AMENDMENT REPORT

Yanco Solar Farm

June 2020

Project Number: 17-326

Figure 1-1 Yanco Solar Farm Constraints Layout

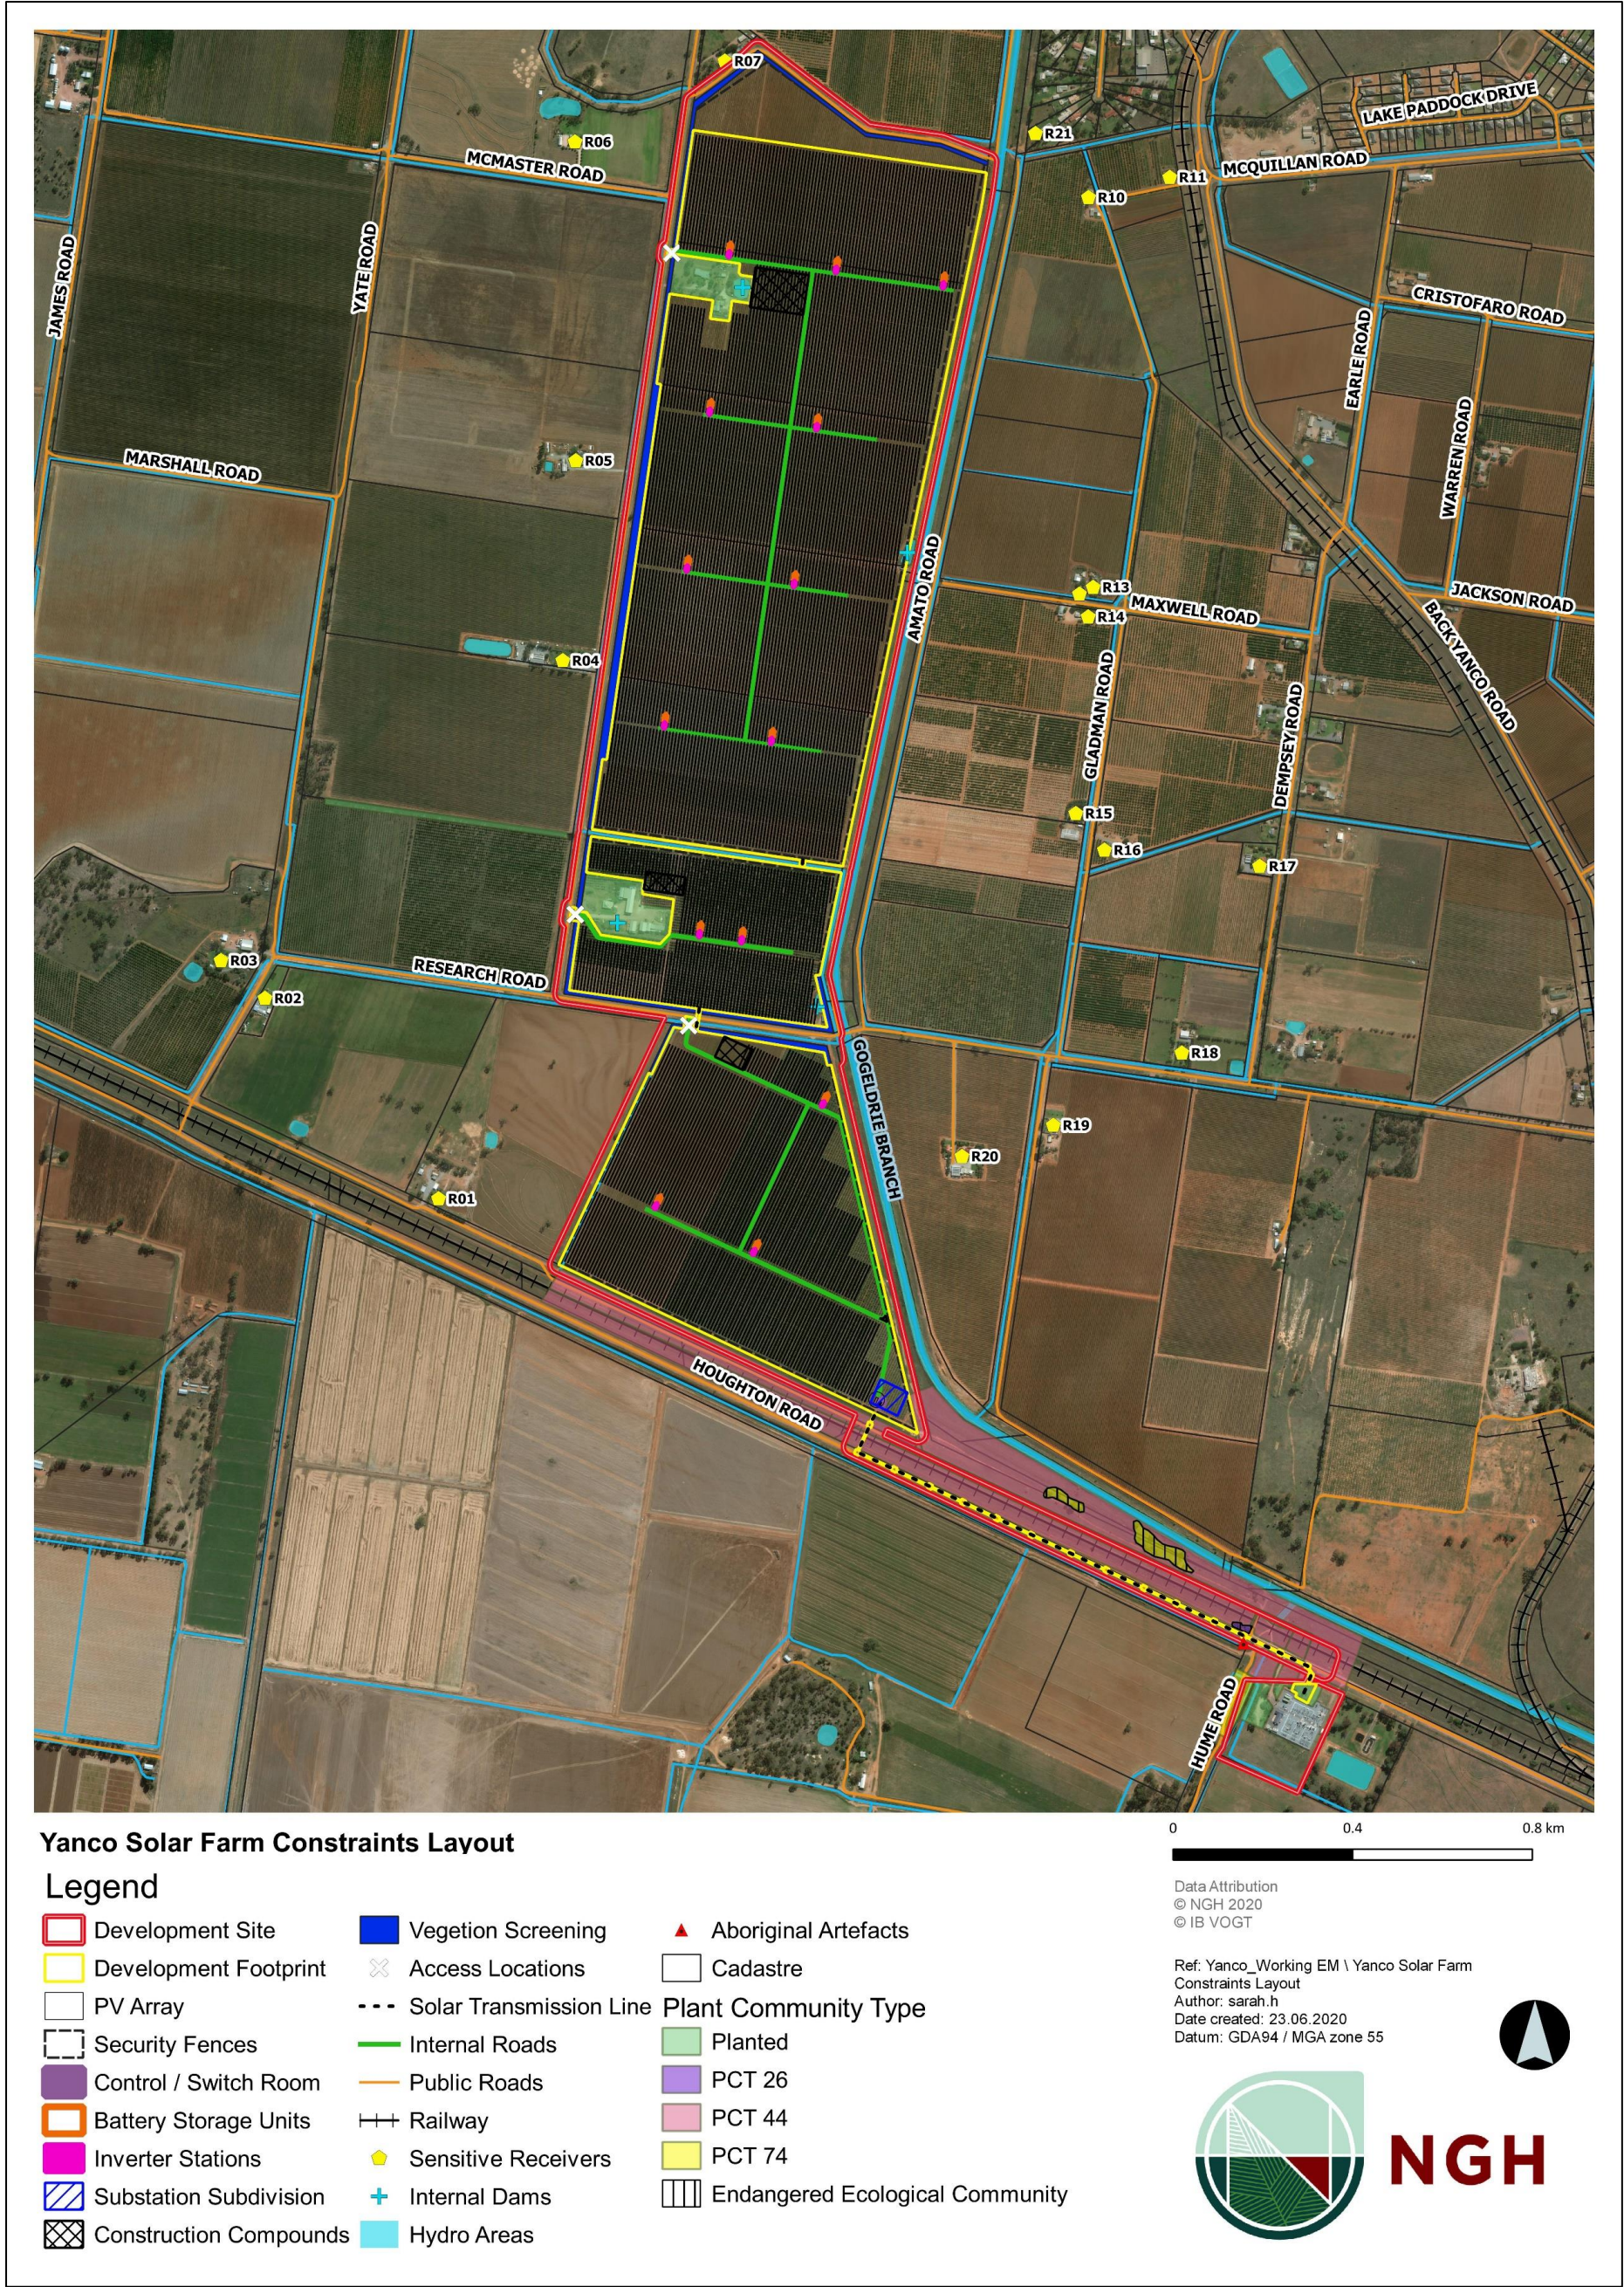
The amended solar infrastructure footprint comprises Lots 145 – 152 DP 751745, Lot 1700 DP 1181161, Lot 10 DP 844961 and Lot 6650 DP 1197165. The railway is comprised of Lot 1700 DP 1181161 and will only be utilised for crossing of the transmission line to the adjacent Houghton's Road reserve. Additional council and rail owned land will be utilised for the proposed transmission line route (Figure 1-1).

The proposed amended solar farm infrastructure maps (Figure 1-1) illustrate the indicative layout, including a concept development footprint for the solar arrays. Detailed design would allow for avoidance of sensitive features on the site.

Figure 1-3 Subject Land

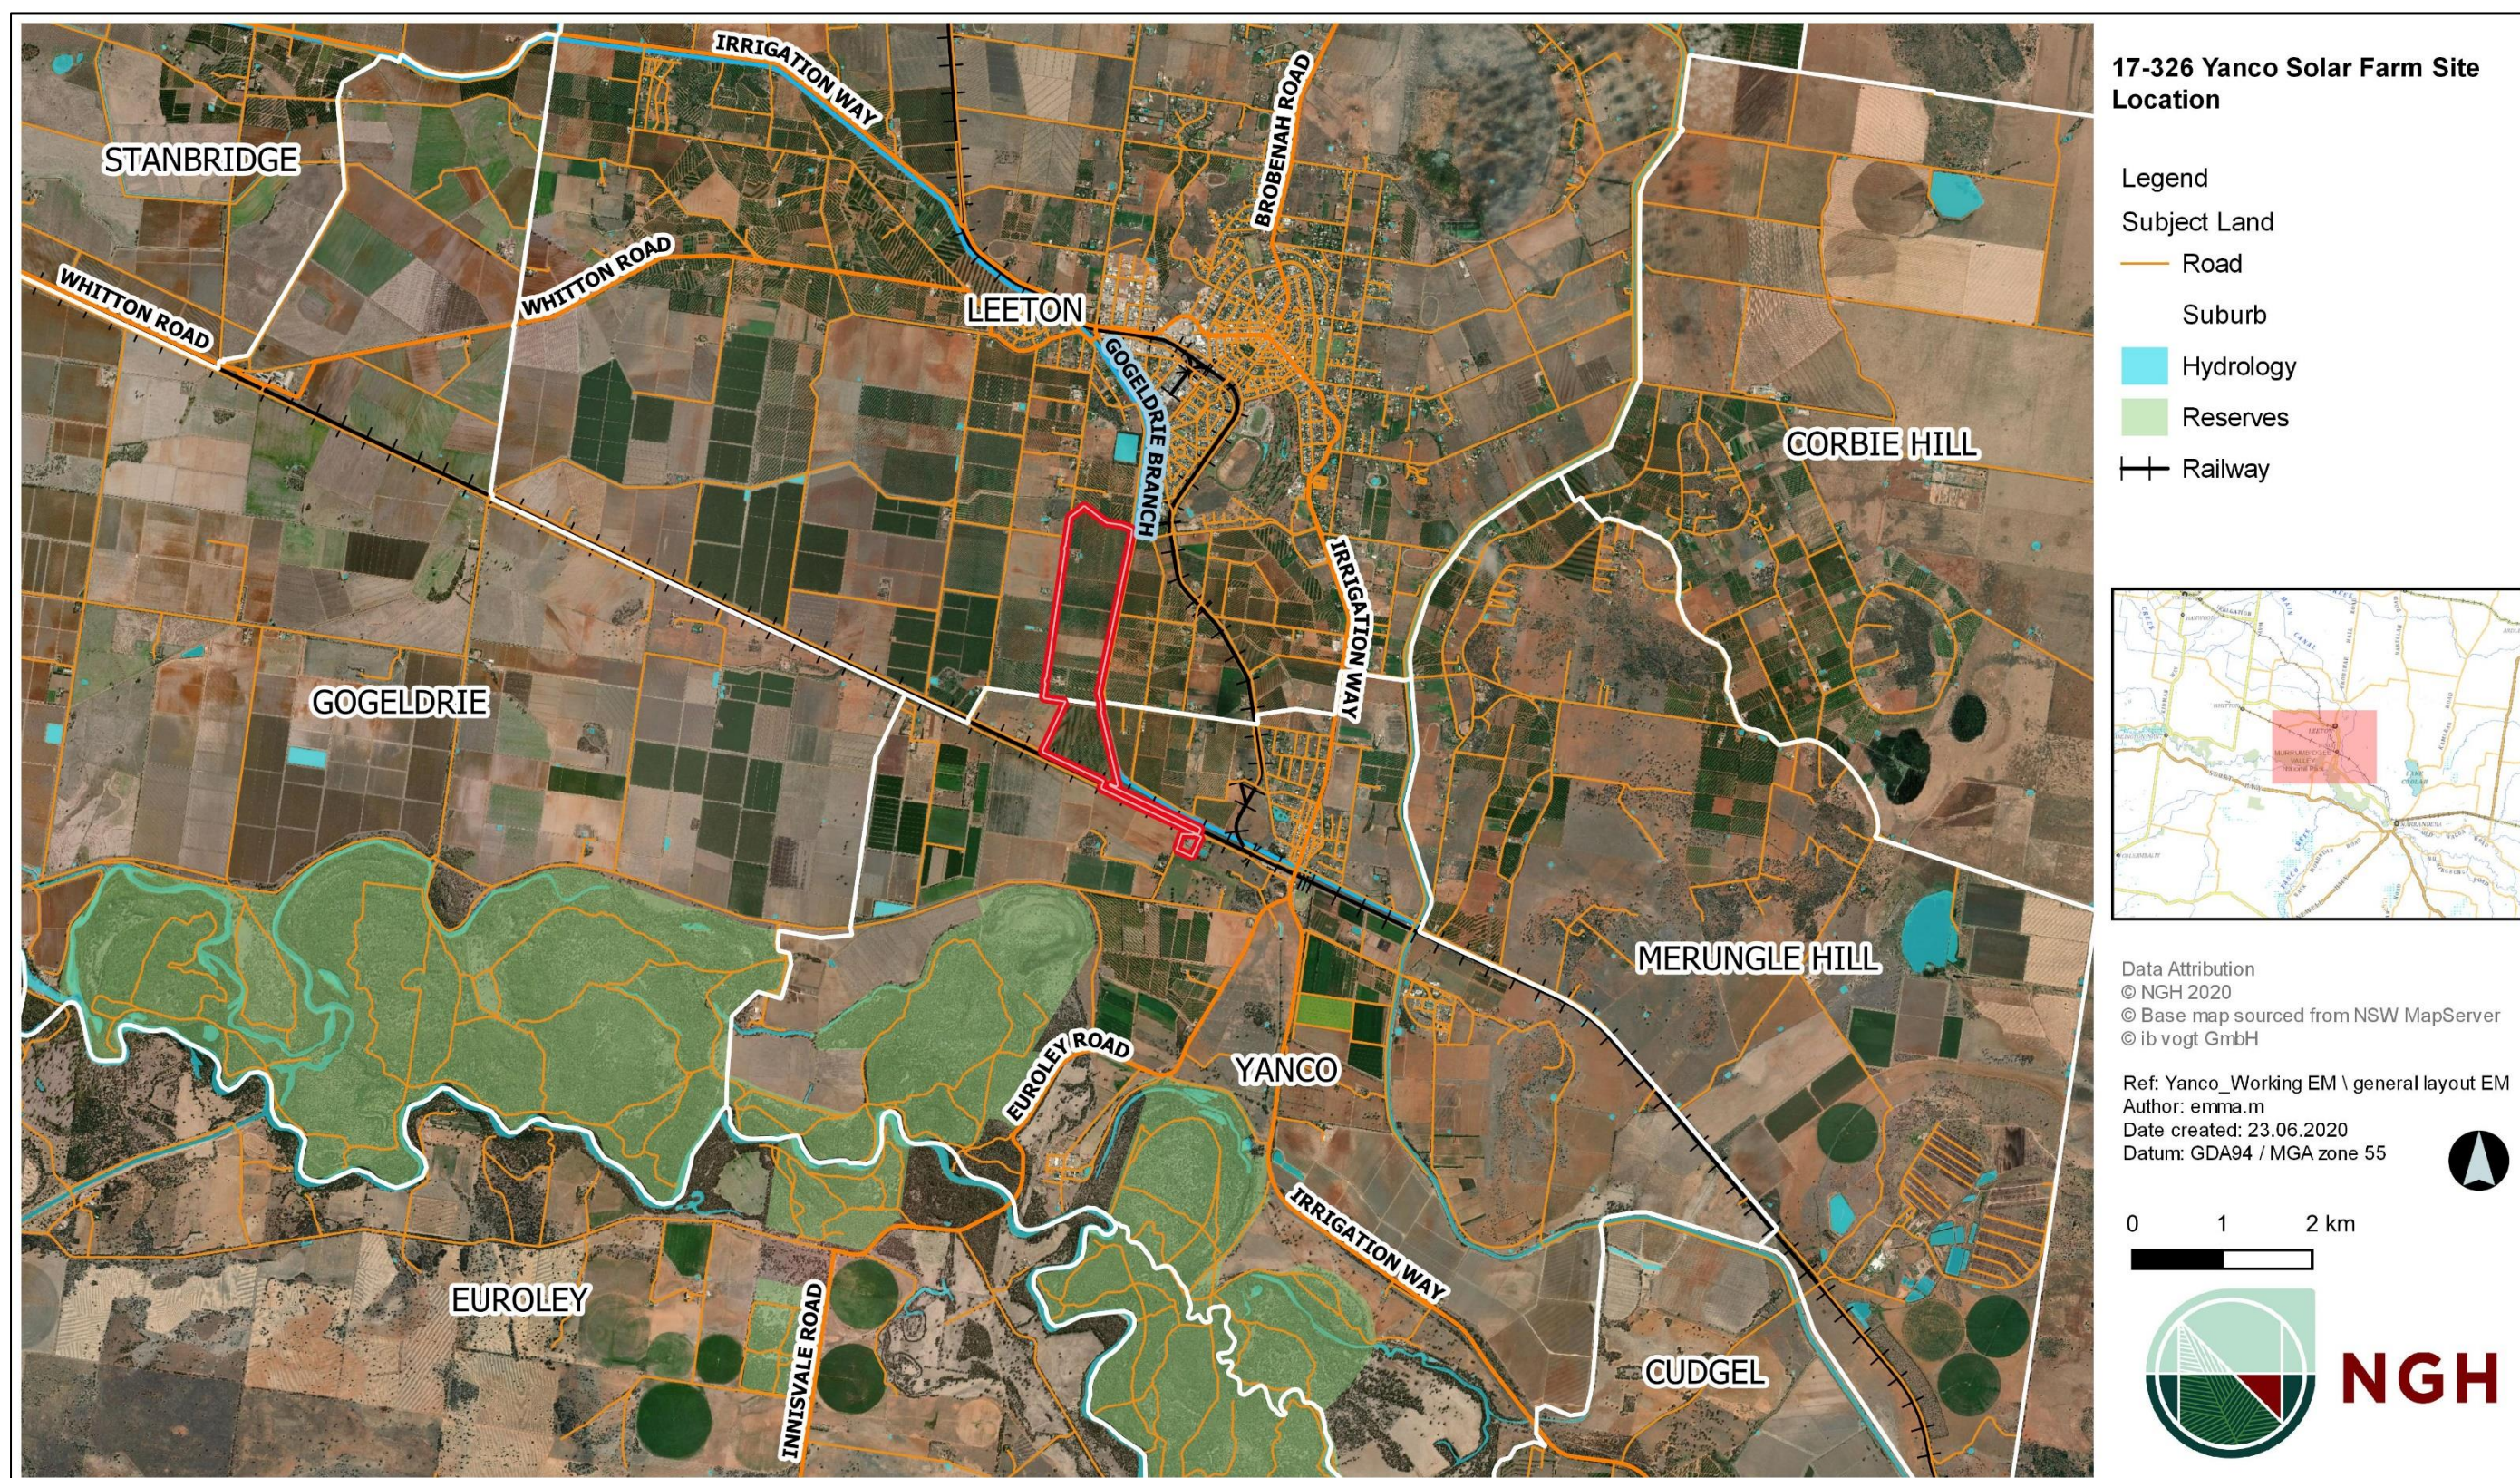
The proposed has been modified to exclude Lot 142 DP751745 from the development area and proposal footprint (Figure 1-3).

Figure 4-1 Location of representative viewpoints (Map source: Google Earth Pro). The lot to be excluded as part of this amendment is indicated with a cross.

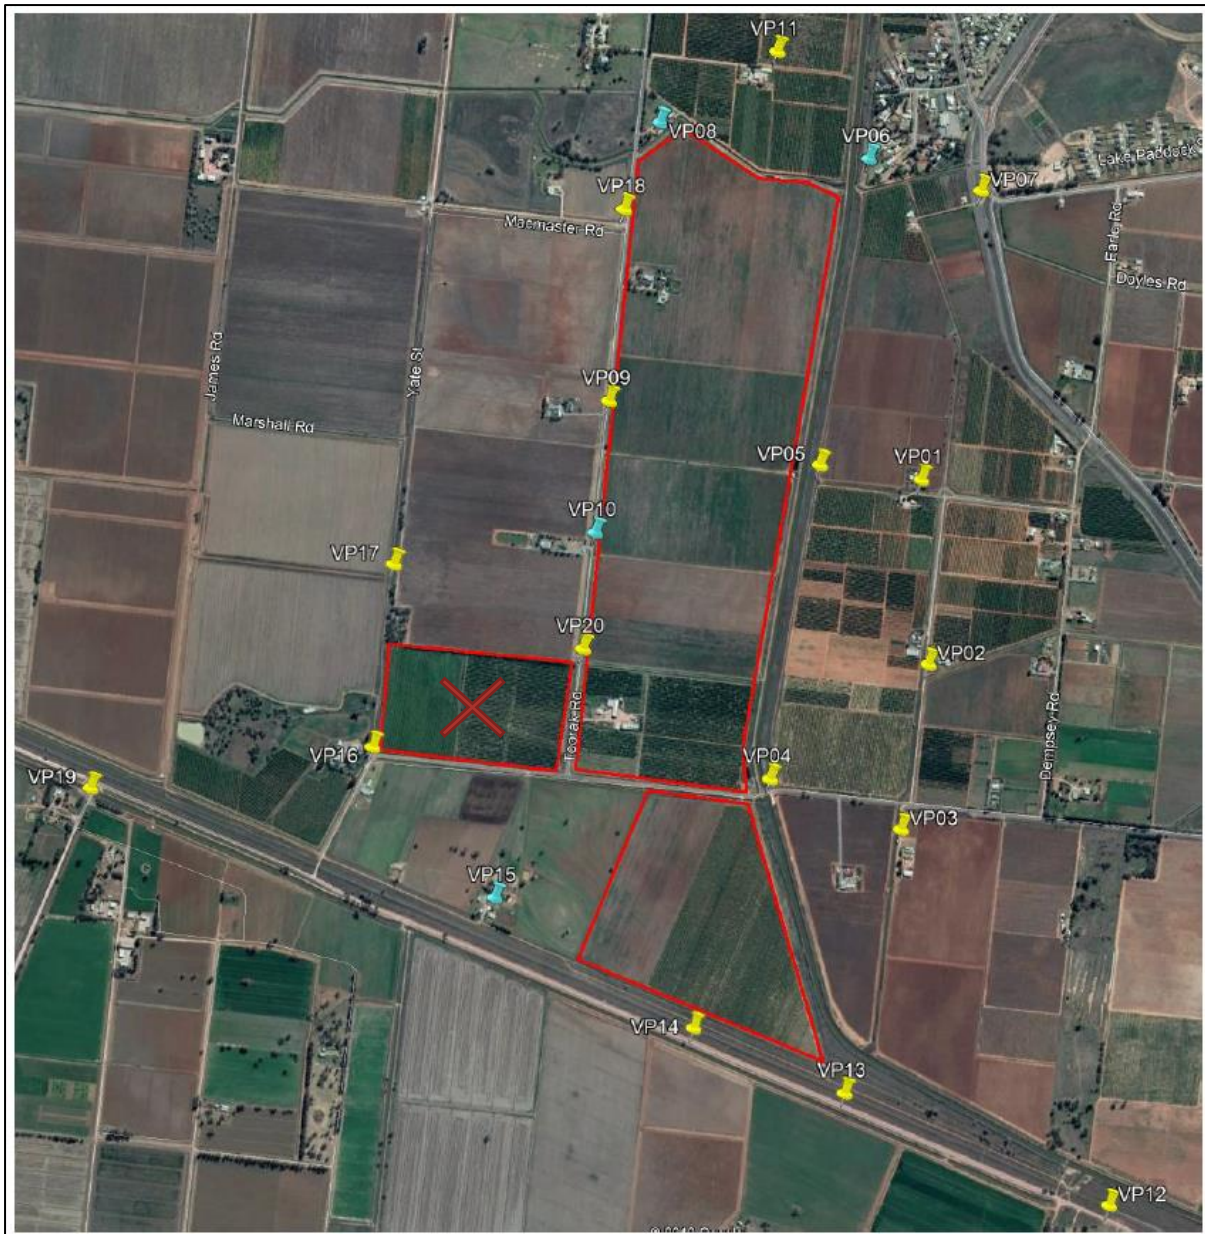
The visual assessment is partly based on the impact and visual change at a number of selected locations. Figure 4-1 shows the location of the twenty viewpoints selected that demonstrate a range of views to the solar farm.

Viewpoints 15, 16, 17, 19 and 20 will have reduced visual impacts due to the exclusion of Lot 142 DP751745. As a result, Receivers R01, R02 and R03 will also have a reduced view of the solar farm, being situated further away from panel infrastructure. The amount of vegetative screening required has been reduced as a result of the amendment (Figure 4-2).
